**Official Transcript of Proceedings**  
**NUCLEAR REGULATORY COMMISSION**

Title: Advisory Committee on Reactor Safeguards

Date: Thursday, November 7, 2024

TerraPower Sodium Topical Report on Plume Exposure  
Pathway Emergency Planning Zone Presentation &  
Discussion.

## Non-seismic Event Selection

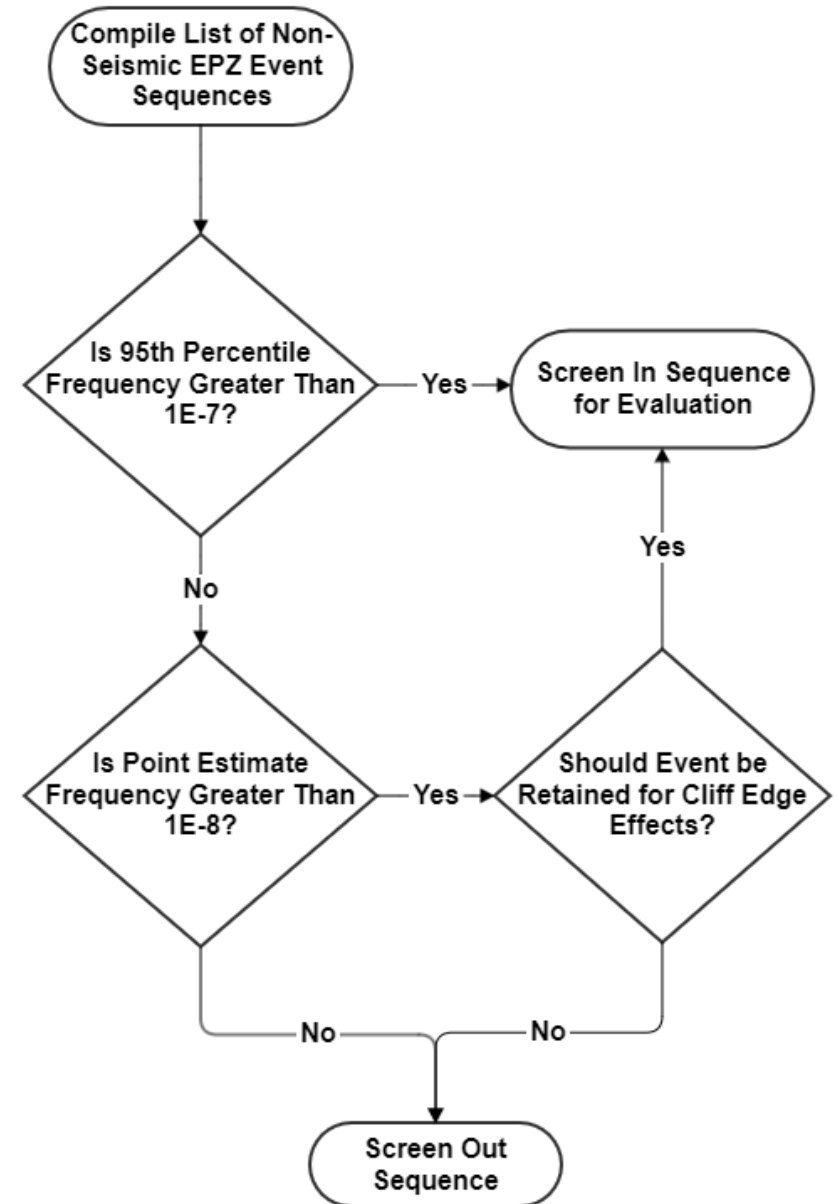
15 I don't think it's a huge safety issue  
16 just because there are, you know, it's in a sense  
17 conservative that you're screening more things in.  
18 But it just seems a little bit illogical from my  
19 perspective. But anyway, I don't think it's a reason,  
20 you know, that this should not be approved or  
21 whatever. But it just seems awkward to me. Anyway,  
22 that's my only comment right now.

- Includes DBAs
- Includes events with a 95<sup>th</sup> percentile release frequency greater than  $1E-7$
- Includes events for cliff-edge consideration if they have a release frequency greater than  $1E-8$

## Non-Seismic Event Selection Example

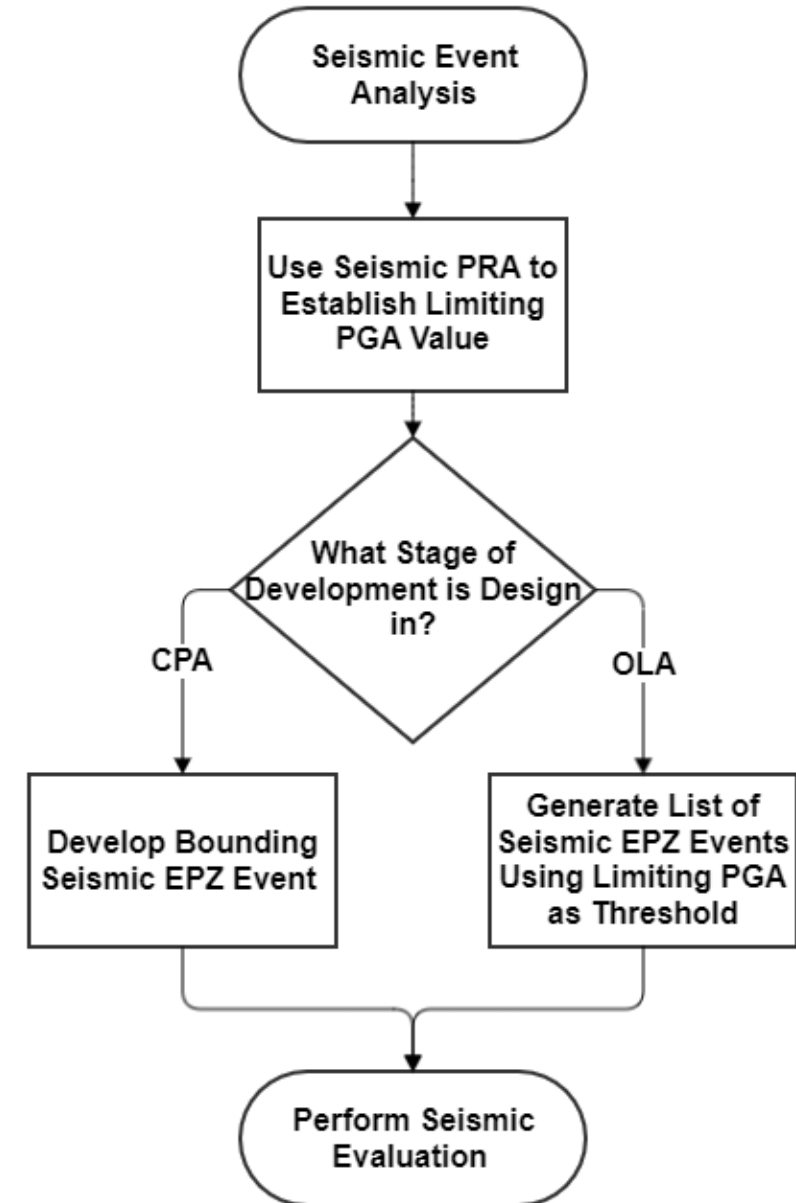
22 MR. PHAN: Thank you. The next question  
23 is whether the mean frequency is equal to or greater  
24 than 1 minus seven per reactor year? If yes, is  
25 included. If no, then the next question is whether

3 Again, if yes, it is included. If no, a  
4 last question is whether the mean frequency is equal  
5 to or greater than 10 to the minus 8 per reactor year?  
6 If yes, the sequence or family, it further assesses  
7 for any cliff-edge effect. If any identified, the  
8 release sequence or family will be included.  
9 Otherwise, it will be excluded from the EPZ dose  
10 calculation.

- Mean:  $2E-7$ , 95<sup>th</sup> percentile:  $6E-7$  screened into EPZ evaluation
- Mean:  $8E-8$ , 95<sup>th</sup> percentile:  $2E-7$  screened into EPZ evaluation
- Mean:  $2E-8$ , 95<sup>th</sup> percentile:  $6E-8$  considered for cliff-edge effects
- Mean:  $8E-9$ , 95<sup>th</sup> percentile:  $2E-8$  screened out of EPZ evaluation
